HEARING DATE: August 8, 2023

TO: Mayor & City Council

SUBJECT: Driftwood Subdivision – CUP, PFP  
[H-2023-0021](#)

LOCATION: 870 W. Ustick Rd., at the NWC corner of W. Ustick Road and N. Venable Avenue, in the SW 1/4 of Section 36, T.4., R.1W.

- A. Site Plan (dated: 4/20/23)

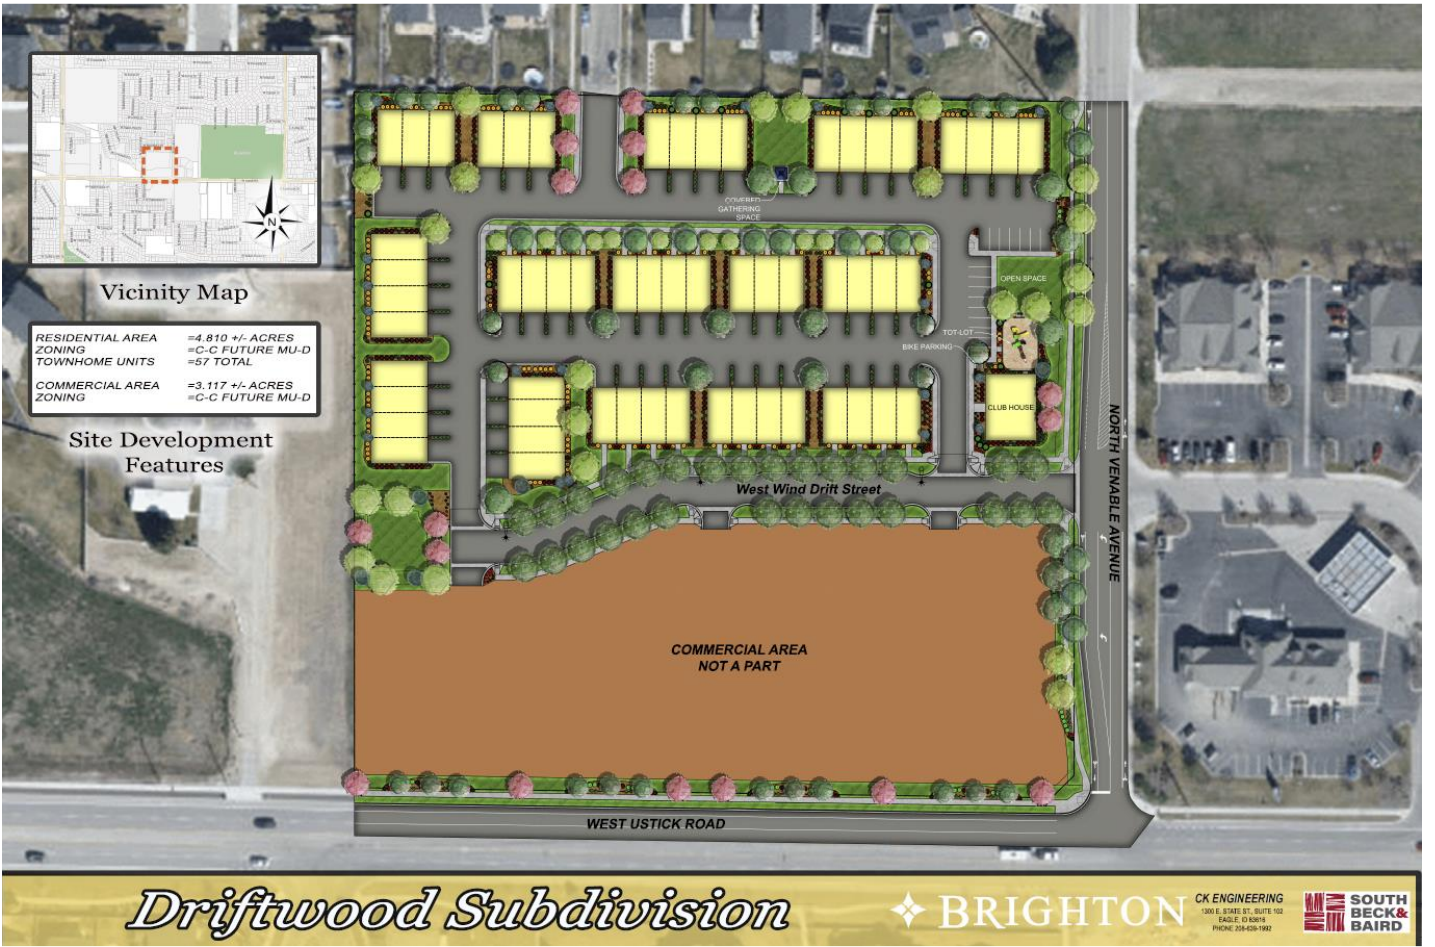
1. Buildings shall provide a minimum setback of ten feet (10’) unless a greater setback is otherwise required by this title and/or [title 10](#) of this Code. Building setbacks shall take into account windows, entrances, porches and patios, and how they impact adjacent properties. **A minimum 25-foot wide buffer to residential uses is required in the C-C zoning district per UDC [Table 11-2B-3](#); therefore, all structures along the north and west boundaries adjacent to residential**

*uses must be setback a minimum of 25 feet from the property line. The plans should be revised to reflect compliance with this standard.*

2. All on-site service areas, outdoor storage areas, waste storage, disposal facilities, and transformer and utility vaults shall be located in an area not visible from a public street, or shall be fully screened from view from a public street. *All proposed transformer/utility vaults and other service areas shall comply with this requirement. A trash dumpster/enclosure should be depicted on the site plan and should accommodate recycling.*

Based on (13) 2-bedroom units and (44) 3-bedroom units, a minimum of 164 off-street parking spaces are required, including guest parking, with 57 of those in a covered carport or garage. A total of 194 spaces are proposed, with 84 of those in garages, which exceeds the minimum standard by 30 spaces. **Accessible parking is required in accord with ADA standards.**

Based on 194 vehicle parking spaces provided, a minimum of eight (8) bicycle parking spaces shall be provided in accord with the design standards listed in UDC [11-3C-5C](#). Five (5) exterior bicycle rack spaces are proposed; **a minimum of eight (8) parking spaces should be provided.**

- a. Depict a minimum 25-foot wide buffer to residential uses along the north and west property boundaries as set forth in UDC [Table 11-2B-3](#) and depict landscaping within the buffer per the standards listed in UDC [11-3B-9C](#). *Buildings shall not encroach within the buffer area.*

- b. All transformer and utility vaults and other service areas shall be located in an area not visible from a public street, or shall be fully screened from view from a public street in accord with UDC [11-4-3-27B.2](#).

- c. Depict bicycle racks capable of holding a minimum of eight (8) bicycles based on 194 vehicle parking spaces provided in accord with UDC [11-3C-6G](#); the design of the bicycle racks shall comply with the standards listed in UDC [11-3C-5C](#).

B. Landscape Plan (dated: 2/28/23) & Open Space and Amenity Details

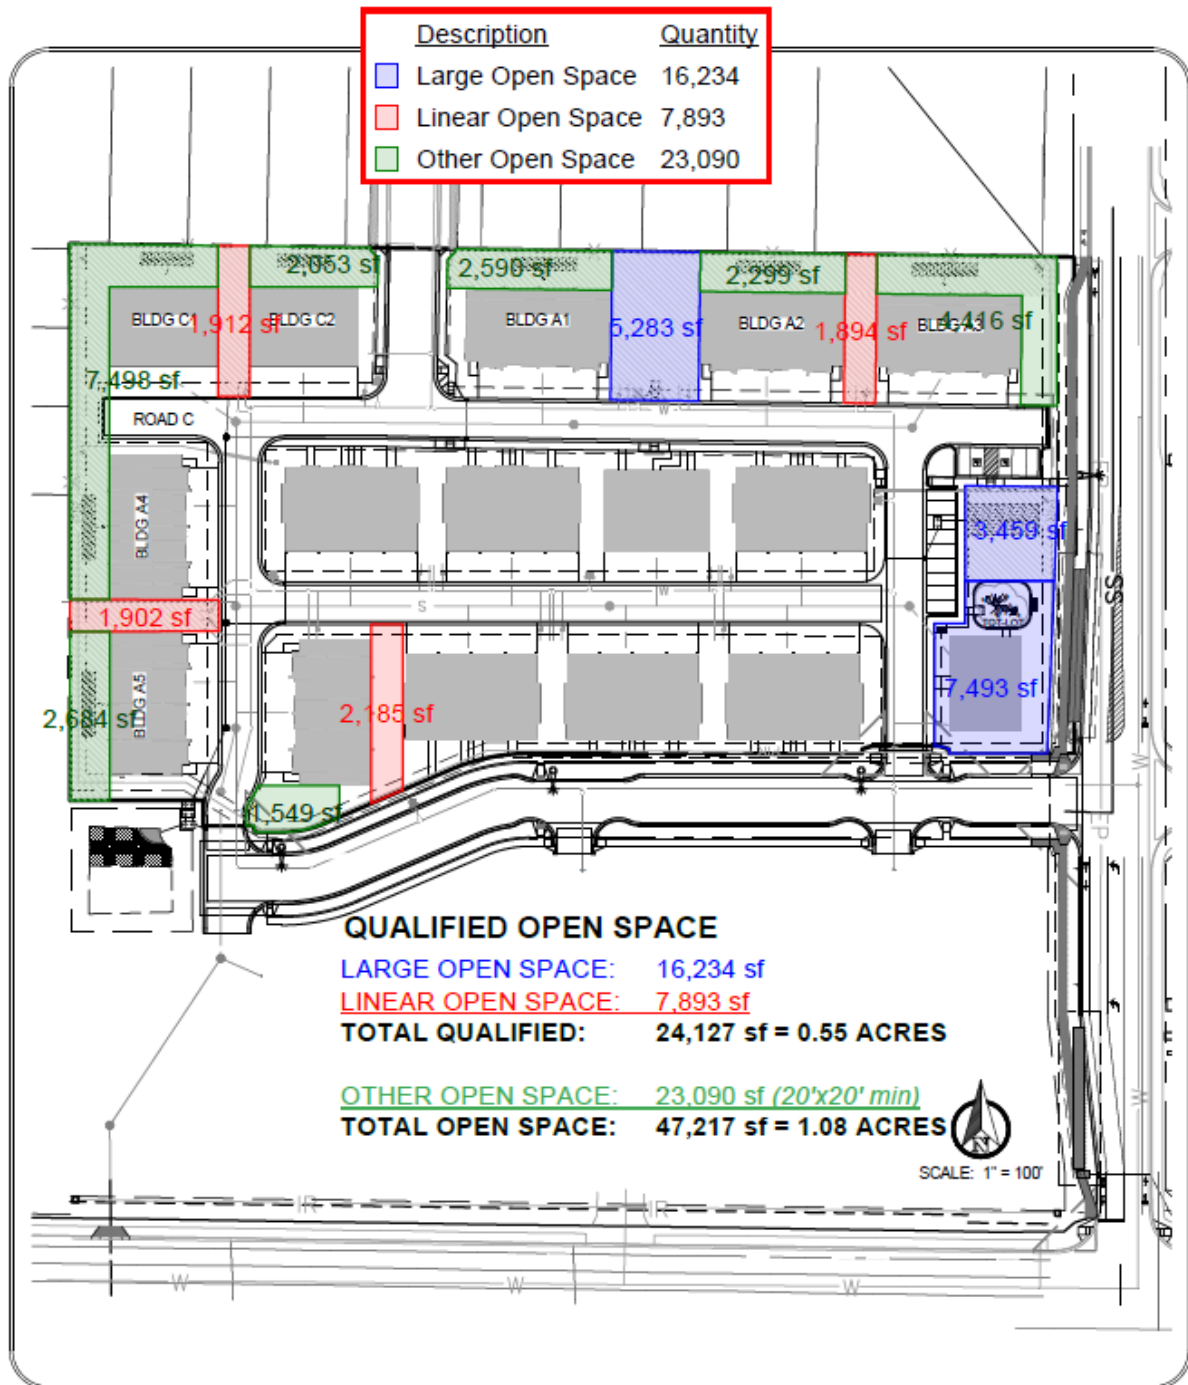
- E. Landscaping Requirements: Development shall meet the minimum landscaping requirements in accord with chapter 3, "Regulations Applying to All Districts", of this title. Additionally, all street facing elevations shall have landscaping along their foundation that complies with the standards listed in UDC [11-4-3-27E.2](#), which requires a landscape area at least 3-feet wide planted with one evergreen shrub every three (3) linear feet that has a mature height of 24-inches with ground cover plants in the remainder of the landscaped area. ***The landscape plan submitted with the Certificate of Zoning Compliance application should be revised to include evergreen shrubs in accord with this standard.***

***Landscaping is required to be provided along all pathways per the standards listed in UDC [11-3B-12C](#), which require a mix of trees, shrubs, lawn, and/or other vegetative groundcover within 5-foot wide strips on each side of the pathway; depict landscaping per these standards along the east/west pathway adjacent to the drive aisle.***

***Street buffer landscaping is required along N. Venable Ave., a collector street, in accord with the standards listed in UDC [11-3B-7C](#) with development of the subdivision. Landscaping should be depicted on the plan in accord with the aforementioned standards.***

***A 25-foot wide buffer is required to adjoining residential uses in the C-C zoning district, per UDC Table 11-2B-3 as shown on the site plan; the landscape plan incorrectly depicts a 15-foot wide buffer which should be revised. Landscaping is required to be installed within the buffer in accord with the standards listed in UDC [11-3B-9C](#). All buffer areas are required to be comprised of, but not limited to, a mix of evergreen and deciduous trees, shrubs, lawn, or other vegetative ground cover that results in a barrier that allows trees to touch within five (5) years of planting. Trees that will not touch until maturity outside of this timeframe must be supplemented with additional***

*materials such as tall columnar evergreen shrubs, or other qualifying materials. A 10-foot wide public utilities, property drainage, and pressure irrigation easement is designated along the boundary of the subdivision, which prohibits trees within the easement – all trees should be planted outside of the easement area.*

**Landscaping** (UDC [11-3B](#)): A 25-foot wide street buffer is required along W. Ustick Rd., an arterial street, and a 20-foot wide street buffer along N. Venable Ave., a collector street, as depicted on the landscape plan. **These buffers shall be depicted on the plat in common lots or dedicated buffer easements, maintained by the property owner, homeowner’s association or business owner’s association as set forth in UDC [11-3B-7C.2a](#).** The buffers should be measured from the back of curb per UDC 11-3B-7C.1a(2).

- g. Depict a minimum of 19,950 square feet (s.f.) (or 0.46-acre) of common open space that complies with the standards listed in UDC [11-4-3-27C.2](#); a minimum of 14,250 s.f. (or 0.33-acre) of that area shall consist of common grassy area in accord with UDC [11-4-3-27C.3](#) commensurate with the size of the development and shall not include the street buffer. *Note: A minimum 5,000 s.f. common grassy area shall be provided in one area; where the remaining area cannot be provided due to site constraints, it may be included elsewhere in the development.*

- h. Depict landscaping along the foundation of all street facing elevations in accord with the standards listed in UDC [11-4-3-27E.2](#). *For every three (3) linear feet of foundation, an evergreen shrub having a minimum mature height of twenty-four (24) inches shall be planted; ground cover plants shall be planted in the remainder of the landscaped area.*

- j. Depict landscaping within the minimum 20-foot wide street buffer along N. Venable Ave., a collector street, in accord with the standards listed in UDC [11-3B-7C](#).

- a. Include a detail of the tot lot play equipment.
  - b. Depict landscaping within the street buffers along N. Venable Ave. and W. Ustick Rd. in accord with the standards listed in UDC [11-3B-7C](#).
